Subject: **URGENT MEDICAL DEVICE REMOVAL – LOT SPECIFIC**

Affected Product: iASSIST Validation Tool

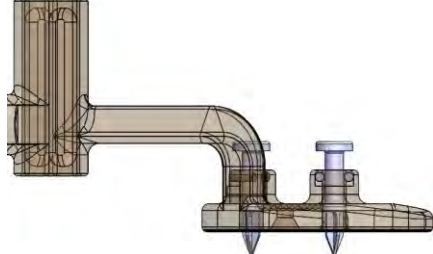
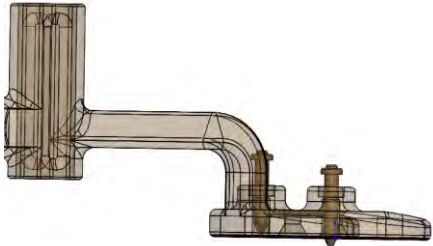
Zimmer Biomet is conducting a medical device field removal for the iASSIST Validation Tool. There has been an increase in the number of complaints regarding bent or broken Drive Pins of the Validation Tool manufactured with drawing Revision M to P, see red box below.

As indicated in the pictures above, drawing revision M to P of the Drive Pins has an X cross section instead of circular. Also, the Drive Pin head has a recess in the enlarged head. Only iASSIST Validation Tools with drawing revision M to P Drive Pins, in the red box above, are affected by this field removal.

<p>Validation tool 20-8011-021-00 Rev R</p> <p>Not affected by the field action</p>		
<p>Validation tool 20-8011-021-00 Rev L</p> <p>Not affected by the field action</p>
